## Cambridge City Council

## PLANNING COMMITTEE MEETING – 6<sup>TH</sup> JANUARY 2016

### Amendment/De-brief Sheet

SUN STUDY - 21<sup>ST</sup> DECEMBER

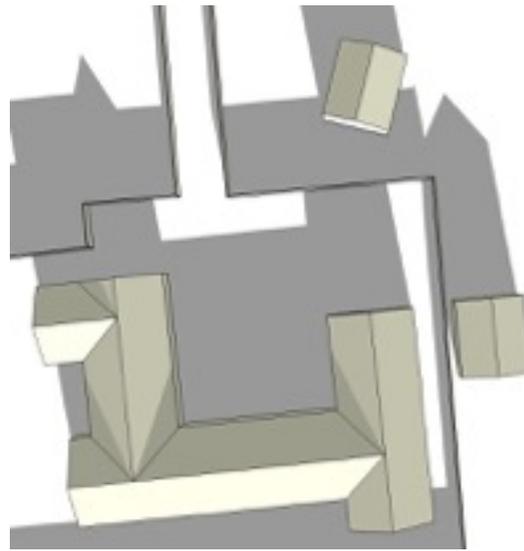
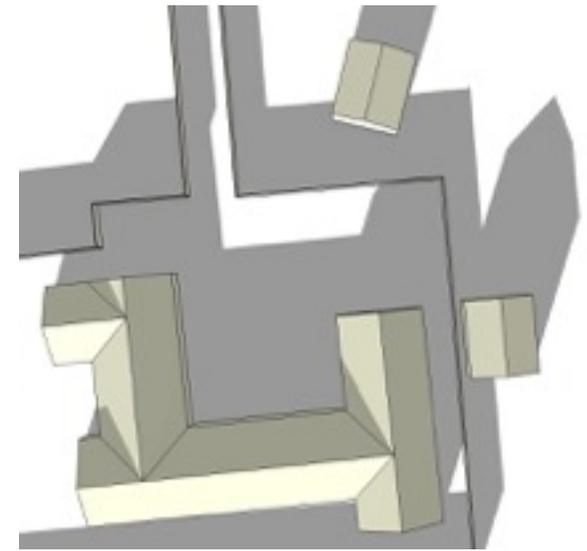
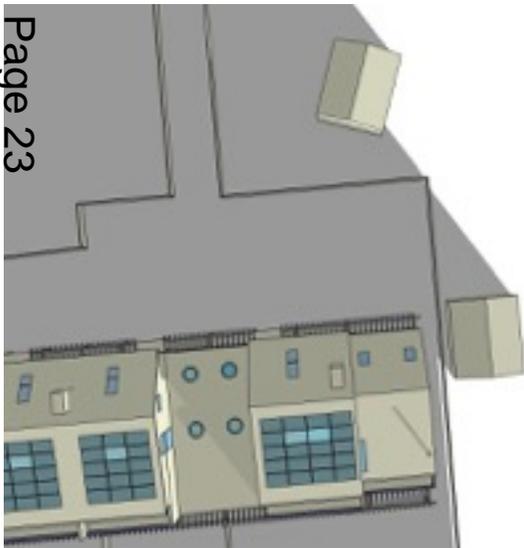
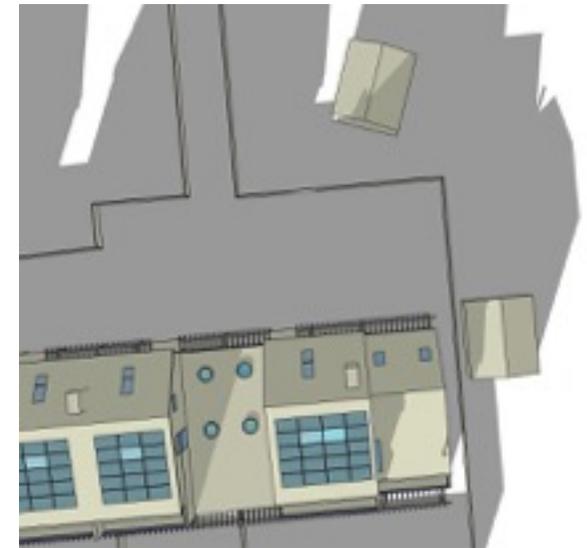
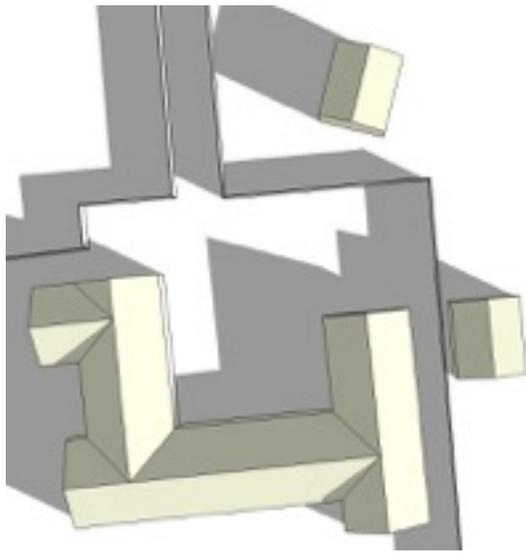
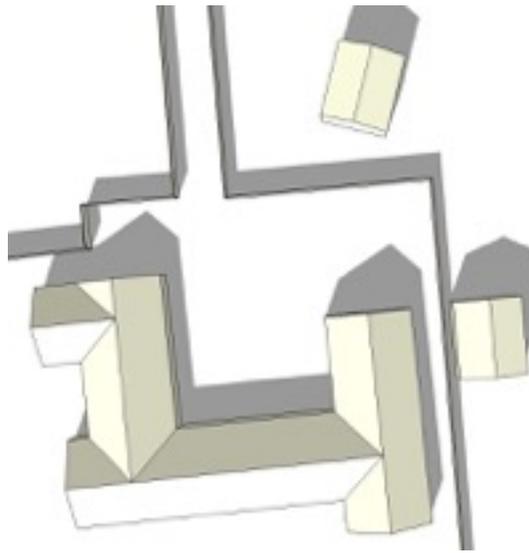
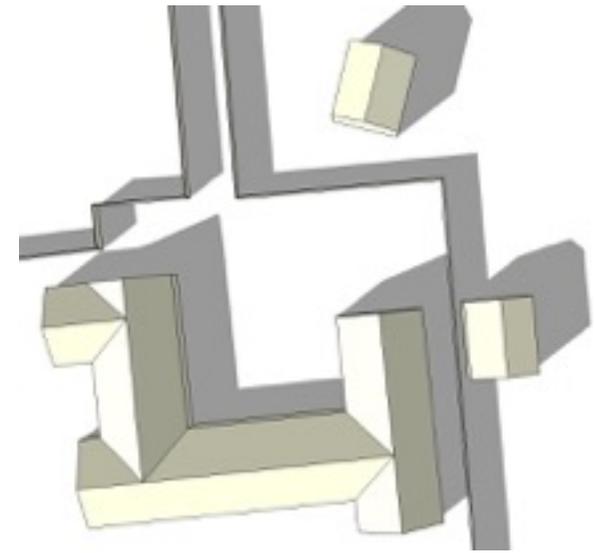
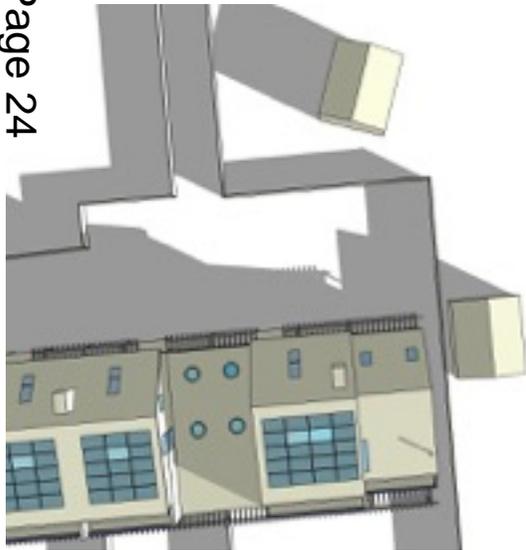
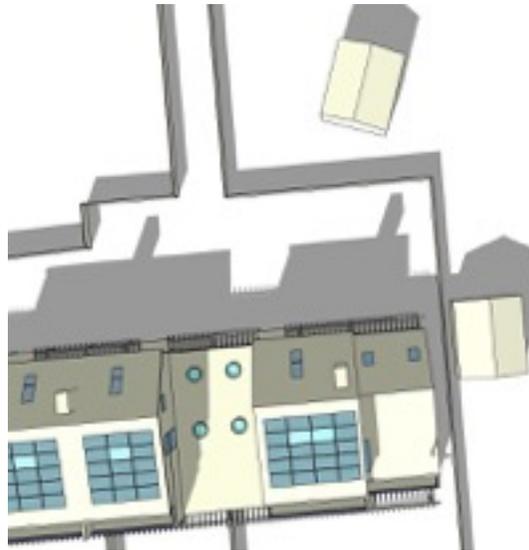
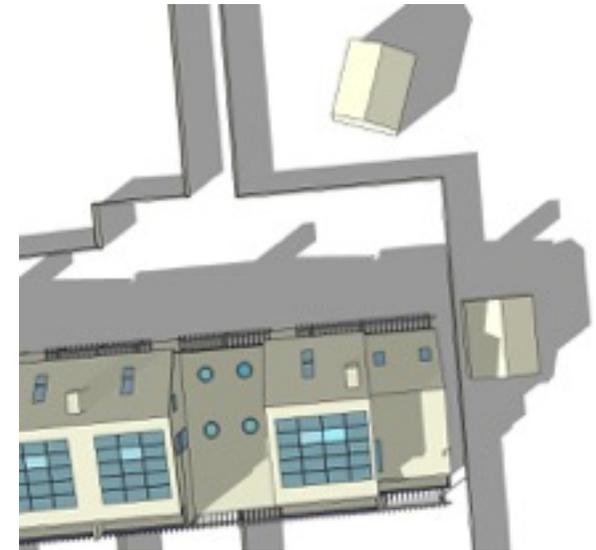
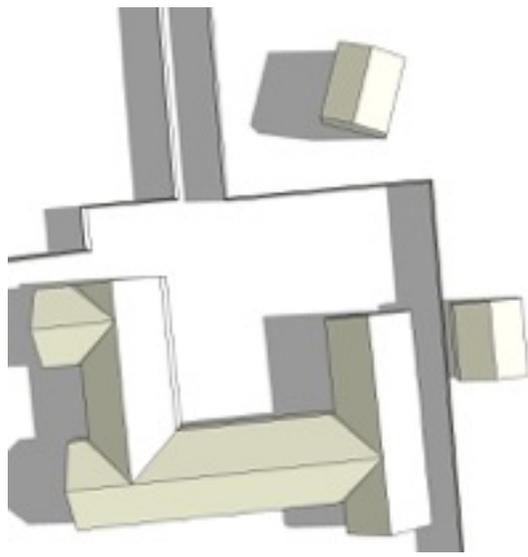
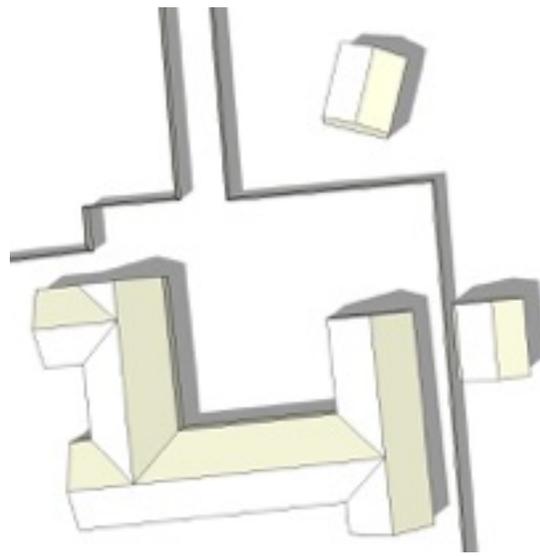
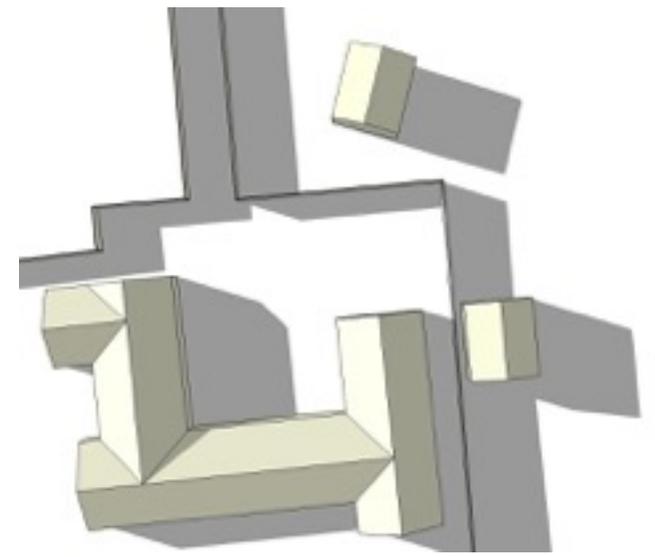
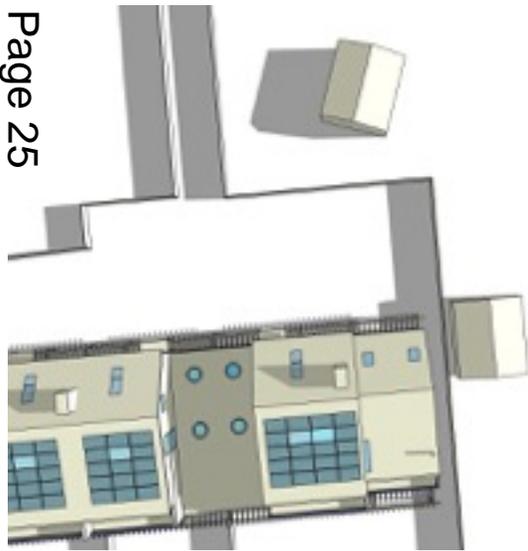
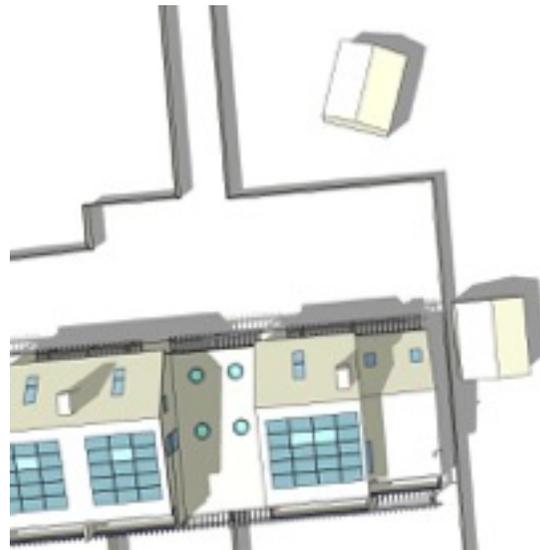
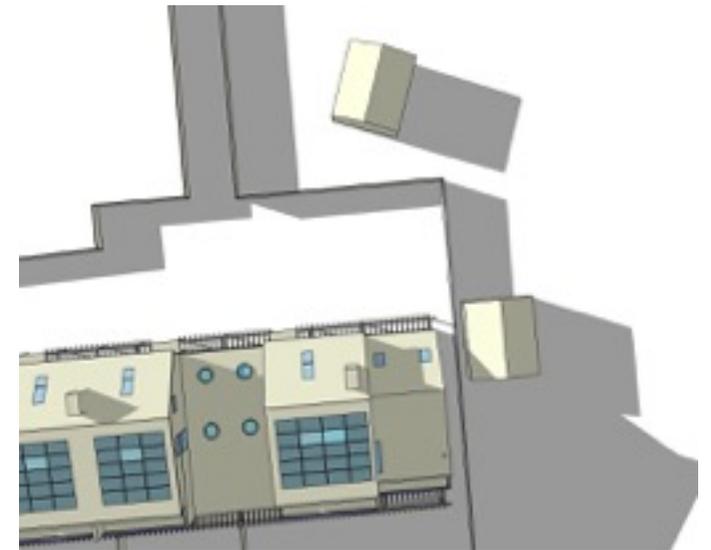
The applicant has submitted a shadow study showing how the proposed development would affect the annexes to the rear of no.64a and 62 Glebe Road – see attached. As you can see from the shadow study, the proposed development would have a negligible impact in terms of overshadowing over and above that which is currently experienced by the occupiers of the two annexes.

This shadow study has not been seen by neighbours as it was received today (5/12/16). Nevertheless, I thought it would be important for members to see this to assist in their consideration of the proposed development.

TITLE: PROPOSED ROAD AND ACCESS DESIGN

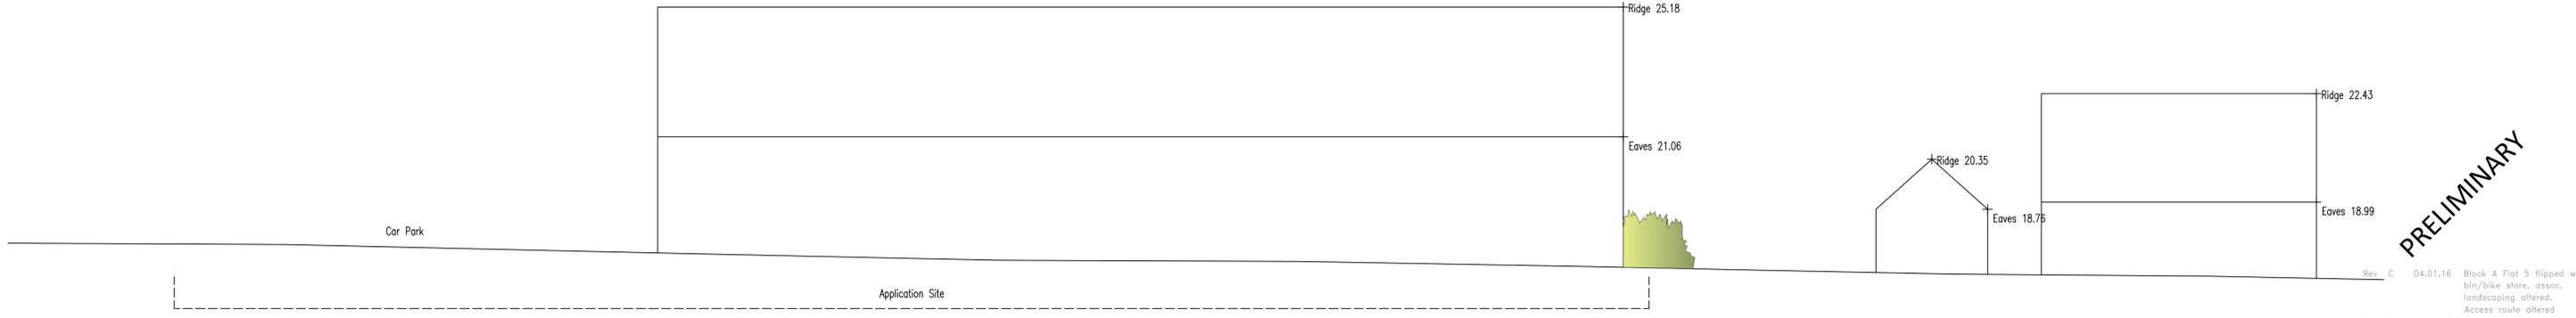
The applicant’s agent has submitted an amended access plan (see Appendix 1) that

reduces the extent of the drive and omits the narrowed/traffic calmed elements from the scheme. It is then intended that any traffic calming measures and other details of the internal road would be the subject of a reserved matters application.

With regards to these issues, the applicant's agent has proposed to amend the plan to cover the access to the highway only and omit the remainder of the access road from the details at this stage. I considered the original access details to be acceptable in highway safety and neighbour amenity terms. However, I also consider the proposed revised details to be acceptable and therefore recommend approval on the basis of this proposed amendment.

- Conditions 11 and 12 – replace the wording ‘driveway’ with the wording ‘access to the highway’.
- Condition 12 – amend wording from 6m to 15m, in order to reflect the Highways Authority’s response.

Title  
**PROPOSED**  
Site Plan & Section

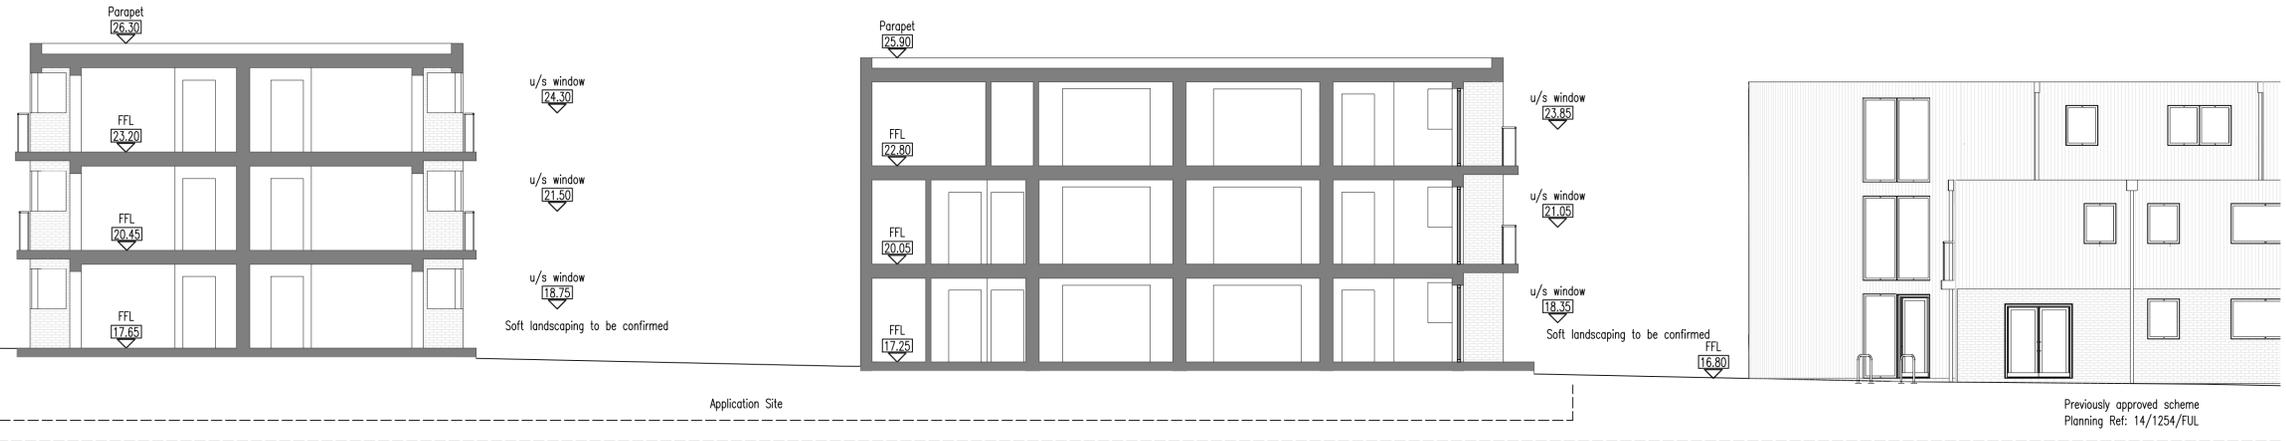
1. Re paragraph 8.61 - A revised site layout plan and access road detail has been received – please see Appendix 1 of this amendment report (plan PL(90)01 Rev C). This has reduced the perceived dominance of the road, by including more passing spaces and roadside planting, and retains the loading areas. This gives greater direction to confirming the finer details of construction (by recommended Condition 27) and removes opportunities for ad hoc parking, assisting enforcement through the parking management plan (Condition 37). The proposal is acceptable to the urban design officer.

- Rev C 04.01.16 Block A Flat 5 flipped with bin/bike store, assoc. landscaping altered.
- Rev B 09.12.15 Access route altered Block B reverted to previous scheme
- Rev A 02.10.15 Landscaping updated Block B updated Block A and parking moved Attenuation tank location Cycle/Bin Store to 149
